# Modification Report

## Tweed Valley Hospital SSD-10353: Changes to Multi-deck Carpark

Prepared for: NSW Health Infrastructure  
© GeoLINK, 2022

**Figure 3.1** Approved south elevation of the multi-deck carpark.

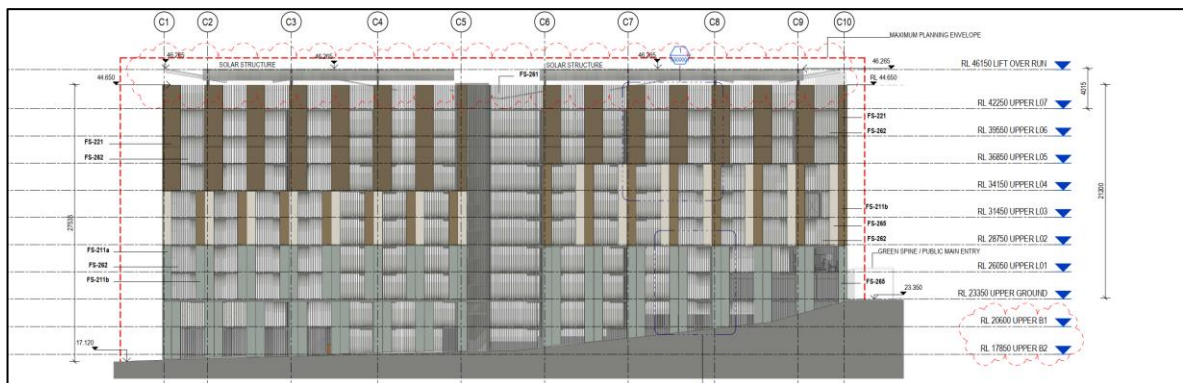
The main change from the approved design is the substitution of the originally proposed precast concrete solid structure with a lightweight perforated aluminium panel system.

The currently approved façade design does not provide the ability to meet the necessary open area (minimum 50%) to achieve the requirements for a naturally ventilated carpark and thus would have triggered the need for a mechanically ventilated system to be introduced. The lightweight perforated aluminium panel system adequately addresses ventilation requirements and avoids the need for mechanical ventilation (except for Basement 2 as discussed at Section 3.6), whilst also being more cost efficient.

Additionally, in order to gain adequate space to fit in the necessary services and maintain compliance with the minimum 2.2m clearance height for cars, the multi-deck carpark building has been dropped/lowered a further 100mm into the ground to a level of RL17.850 (was RL17.950). As a result, the two lower levels have had their finished floor levels (FFL) marginally changed and a minor extent of additional earthworks would be required to facilitate site levels for construction. There is no change to the overall height of the carpark's main facade above existing ground level (remains at RL44.650) or lift overrun (remains at RL46.150).

**Figure 3.1** and **Figure 3.2** provide a sample comparison of the approved and modified southern elevations of the multi-deck carpark. Architectural renders showing the similarity between the original and modified multi-deck carpark appearance are at **Figure 3.3** and **Figure 3.4**. Refer to modified plan set for full details and all plans/elevations, including the updated render of the multi-deck carpark.

**Figure 3.5 Sample elevations and example image of rooftop solar system/shade structure to be installed over car parking spaces.**

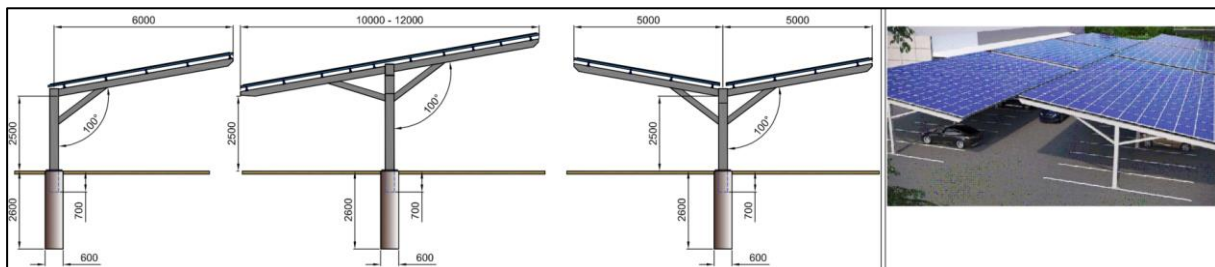
The provision of a PV solar system would complement the site-wide strategy to provide environmentally sustainable design in the Tweed Valley Hospital precinct. The proposed system would have a total power generation capacity of 507.6 kWp (kilowatts peak). Power generated from the solar system would be fed back into the hospital grid and support the energy and sustainability credentials of the Project for its long-term operation.

The solar panels would be installed atop an elevated steel structure that would be constructed over the upper-level car spaces (at each respective stage as outlined in **Section 3.3.1**). The solar structure would be a maximum of 4.015m high above the carpark floor level and result in the overall building height of the multi-deck carpark marginally increasing from RL46.150 to RL46.265. The entire multi-deck carpark structure, including solar structure installation, would remain well within the approved concept building/planning envelope associated with development consent SSD-9575. Sample elevations and an example image of the solar/shade structure are provided in **Figure 3.5**. Refer to modified plan set for full details.
